Beaver Valley Power Station

1/2-ODC-1.01

ODCM: Index, Matrix and History of ODCM Changes

Revision Number	10
Level Of Use	General Skill Reference
Safety Related Procedure	Yes
Effective Date	12/22/10

FIGURE 1.4-1
BV-1 LIQUID RADWASTE SYSTEM

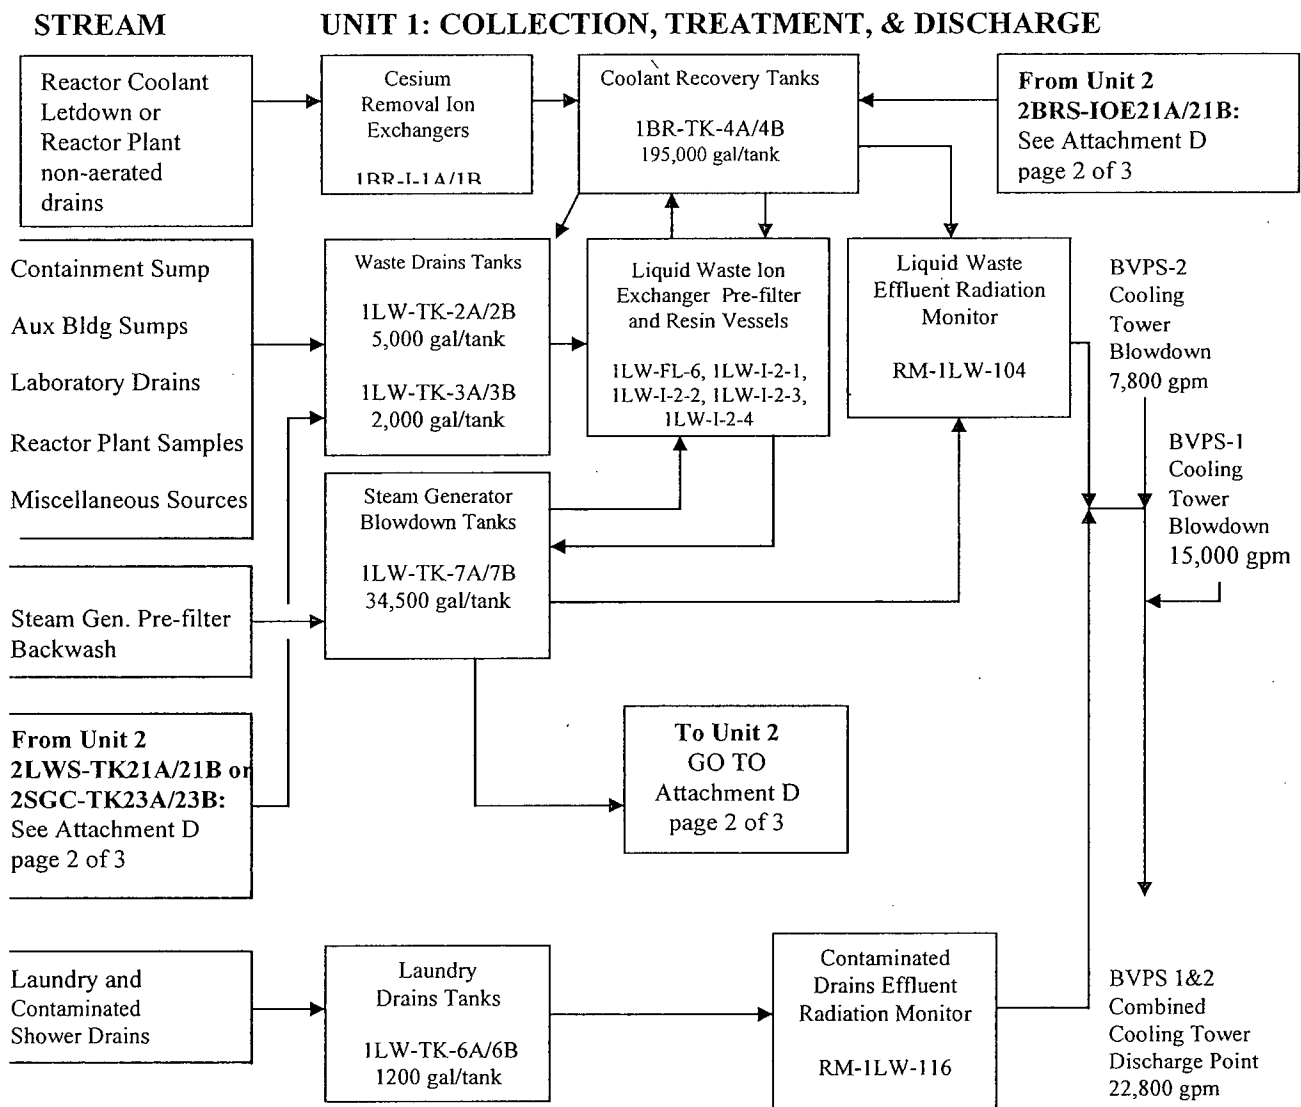
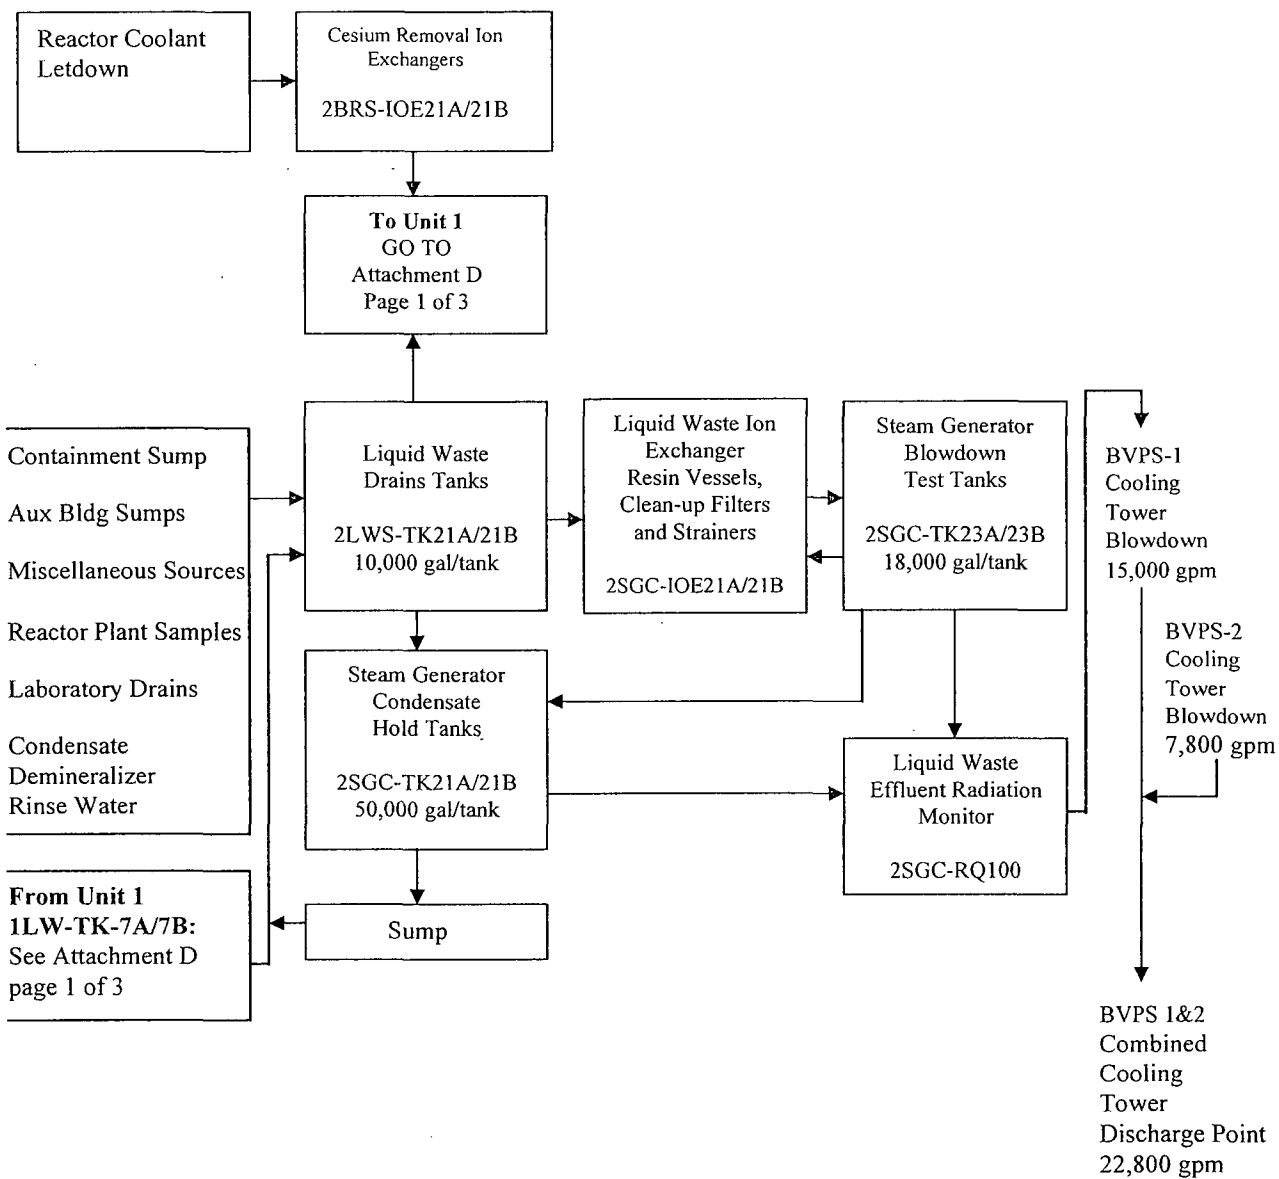
3.2.2.43	CR 05-00004-15, CR 05-00004-17 and SAP Order 200197646-0010 to revise 1/2-ODC-2.01. Add the Coolant Recovery Tanks [1BR-TK-4A/4B] as Liquid Waste Tanks to Section 8.4 description and Attachment D Figures 1.4-1 and 1.4-2. Add a default 2-tank volume recirculation time of 45.7 hrs for the Coolant Recovery Tanks [1BR-TK-4A/4B] to Attachment B Table 1.2-1a. Add the Cesium Removal Ion Exchangers [1BR-I-1A/1B and 2BRS-IOE21A/21B] to Section 8.4 description and Attachment B Figures 1.4-1 and 1.4-2. Revise the recirculation times in Attachment B Table 1.2-1a and 1.2-1b to indicate the times for nominal tank volume and maximum tank volume.

8.2.25.1.4	<p><u>Procedure 1/2-ODC-2.01, Rev 6:</u> Added the Coolant Recovery Tanks [1BR-TK-4A/4B] as Liquid Waste Tanks to Section 8.4 description and Attachment D Figures 1.4-1 and 1.4-2. Added a default 2-tank volume recirculation time of 45.7 hrs for the Coolant Recovery Tanks [1BR-TK-4A/4B] to Attachment B Table 1.2-1a. Added the Cesium Removal Ion Exchangers [1BR-I-1A/1B and 2BRS-IOE21A/21B] to Section 8.4 description and Attachment B Figures 1.4-1 and 1.4-2. Revised the recirculation times in Attachment B Table 1.2-1a and 1.2-1b to indicate the times for nominal tank volume and maximum tank volume. Reference CR 05-00004-15, CR 05-00004-17 and SAP Order 200197646-0010.</p>

8.2.27.1.6	<p><u>Procedure 1/2-ODC-2.01, Rev 8:</u> Added the Coolant Recovery Tanks [1BR-TK-4A/4B] as Liquid Waste Tanks to Section 8.4 description and Attachment D Figures 1.4-1 and 1.4-2. Added a default 2-tank volume recirculation time of 45.7 hrs for the Coolant Recovery Tanks [1BR-TK-4A/4B] to Attachment B Table 1.2-1a. Added the Cesium Removal Ion Exchangers [1BR-I-1A/1B and 2BRS-IOE21A/21B] to Section 8.4 description and Attachment B Figures 1.4-1 and 1.4-2. Revised the recirculation times in Attachment B Table 1.2-1a and 1.2-1b to indicate the times for nominal tank volume and maximum tank volume. Reference CR 05-00004-15, CR 05-00004-17 and SAP Order 200197646-0010.</p>

FIGURE 1.4-3
BV-1 AND 2 LIQUID EFFLUENT RELEASE POINTS

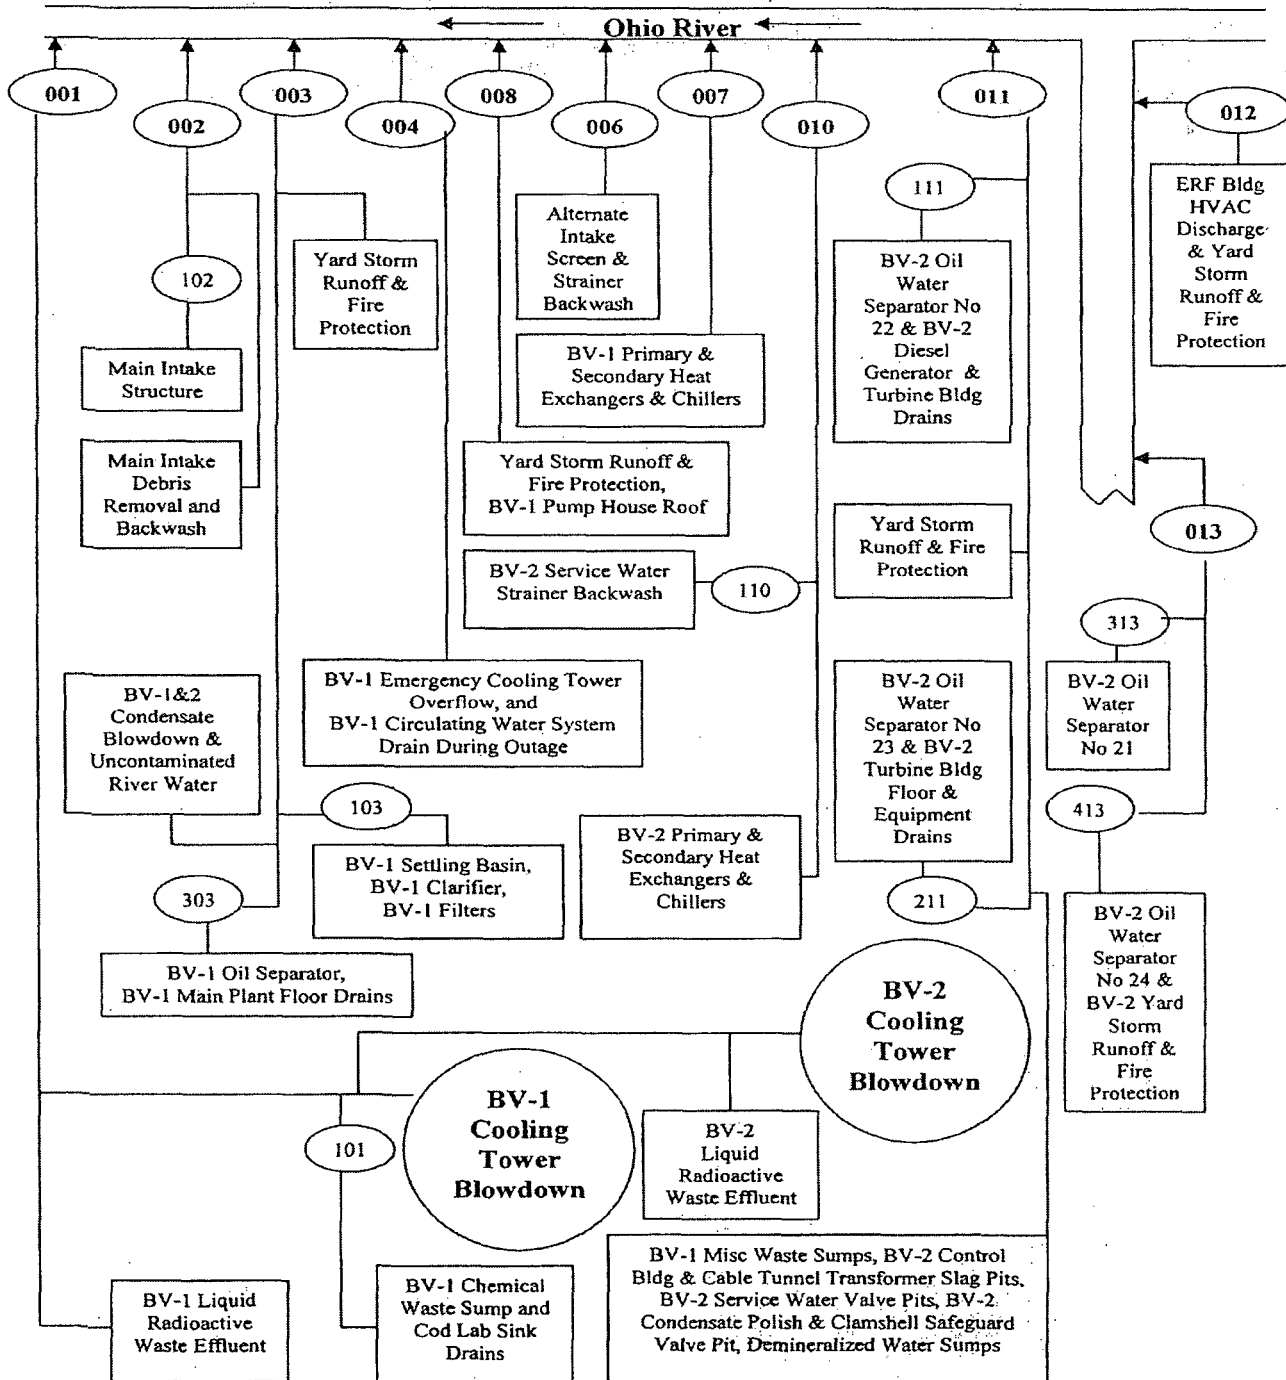
3.2.2.30	CR 05-03854, ODCM Figure for Liquid Effluent Release Points Needs Updated. CA-01, revise ODCM procedure 1/2-ODC-2.01 (ODCM: Liquid Effluents) Attachment D, Figure 1.4-3 to incorporate a modified version of Plant Drawing No. 8700-RM-27F.

3.2.2.44	SAP Order 200197646-0660. Revise 1/2-ODC-2.01 Attachment D Figure 1.4-3 to remove STP Outfalls 113 and 203 due to retirement of the Sewage Treatment Plants and to remove Outfall 501. Water is no longer discharged via these outfalls.

8.2.25.1.5	<p><u>Procedure 1/2-ODC-2.01, Rev 6:</u> Revised Attachment D Figure 1.4-3 to remove Sewage Treatment Plants (STP) Outfalls 113 and 203 due to retirement of the STP and to remove Outfall 501. Water is no longer discharged via these outfalls. Reference SAP Order 200197646-0660.</p>

8.2.27.1.4	<p><u>Procedure 1/2-ODC-2.01, Rev 8:</u> Revised Attachment D Figure 1.4-3 to remove Sewage Treatment Plants (STP) Outfalls 113 and 203 due to retirement of the STP and to remove U1 Steam Generator Blowdown Filter Backwash Outfall 501. Water is no longer discharged via these outfalls. Reference SAP Order 200197646-0660.</p>

FIGURE 2.4-2

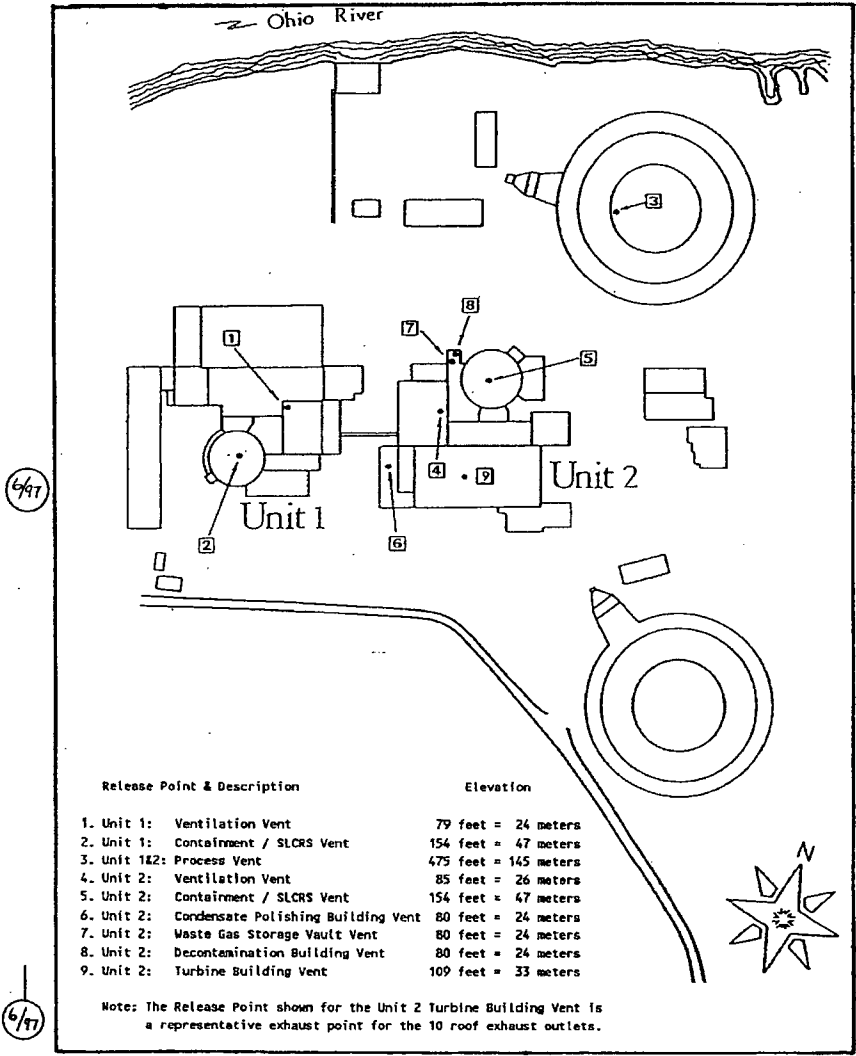
8.2.10.1.1 Section 2.0: A release point for the BV-2 Turbine Building Vent was added (for editorial purposes) to Figure 2.4-2.
